The following statement is intended to discuss the requested 150mm deep window reveal with the development and the issues associated with its implementation. These issues include thermal efficiency, aesthetics, and practicality. We are proposing to change this to a 100mm reveal with a slimmer window frame than that approved. The result is an overall slimmer window detail that is more in-keeping with the original design intent.

Figure 9: Window Frame Fitted in a Separate Fix to Kingspan Thermabate®

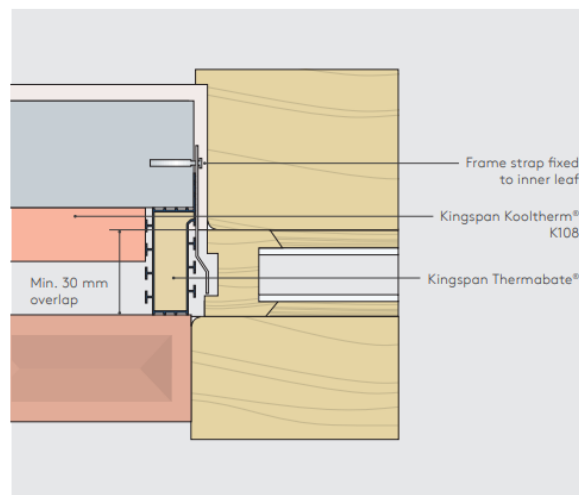
If we were to adopt a 150mm reveal the size of the cavity closer would be reduced to 50mm, thus reducing the insulation levels and thermal efficiency.

Checked rebate window frame detail for areas of severe exposure

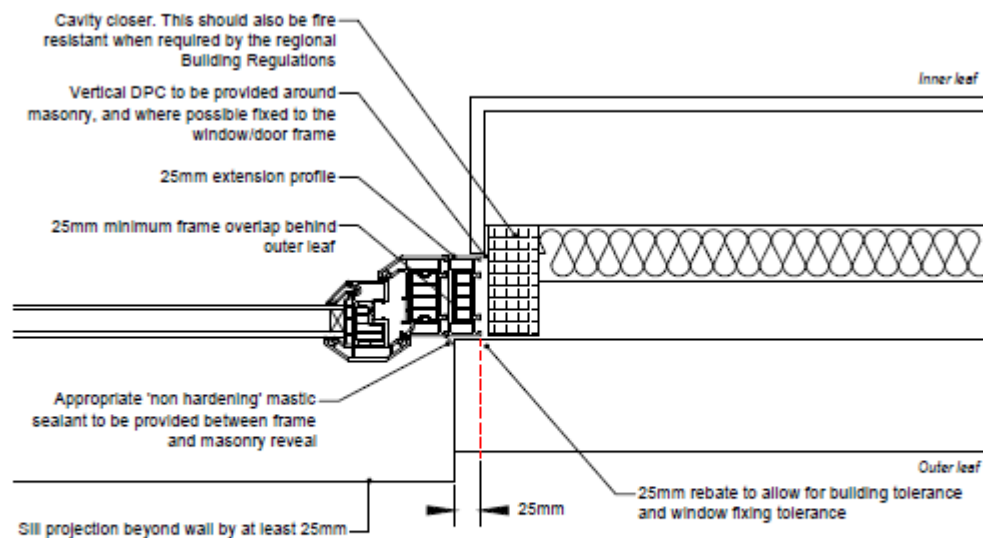
When installing window/door frames in a checked rebate, allow for the frame to be deeper:

- To accommodate the 25mm rebate, and
- To allow for opening lights to open clear of the masonry/render.

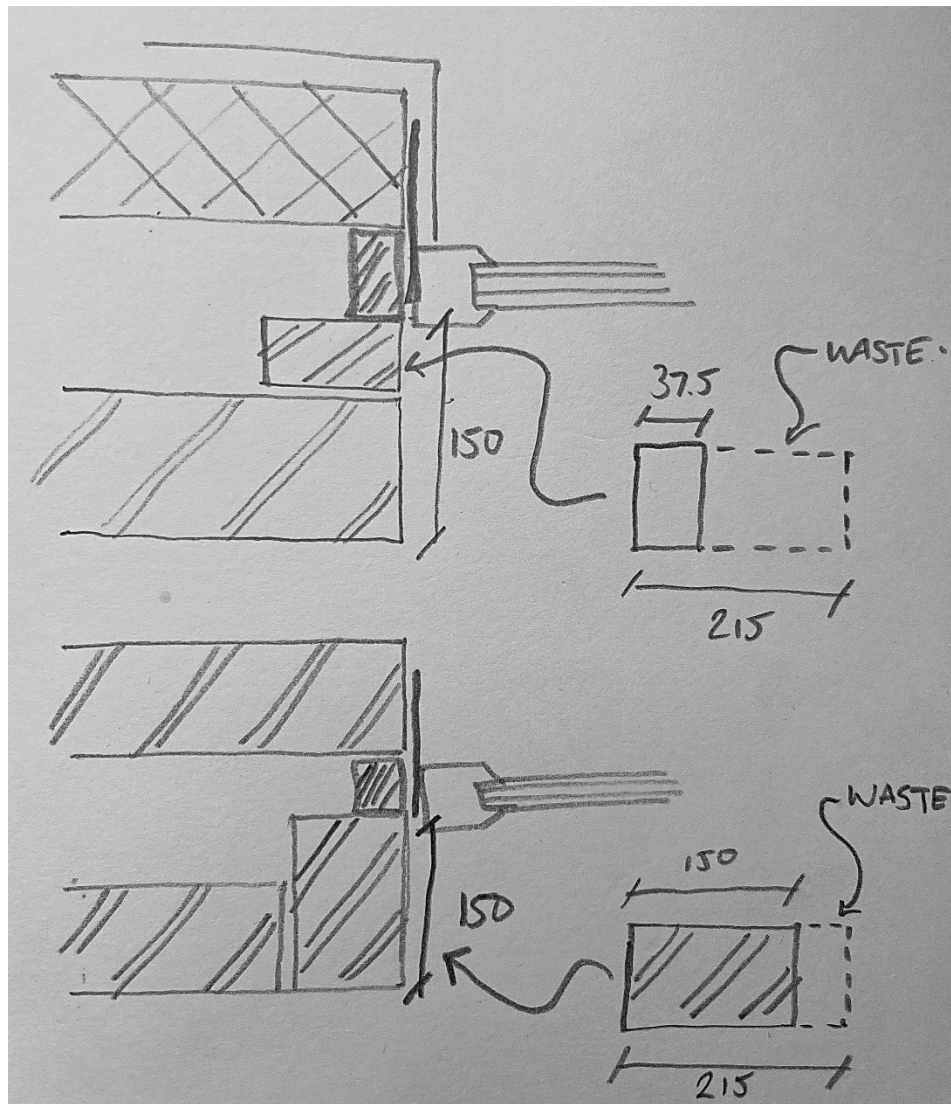
A standard metric brick is 215 x 102.5mm. Therefore to create a 150mm deep reveal requires an additional brick for every other course. The reveal brick then has to be cut on every course. This exercise is labour intensive and also increases wastage. This situation is also repeated on the

window heads where we have soldier bricks with the brick exposed on the soffit. In this instance we then need to introduce an additional cut brick behind the soldier which creates the same issues as the reveal. On a development of this scale this has an impact on the overall delivery of the scheme.
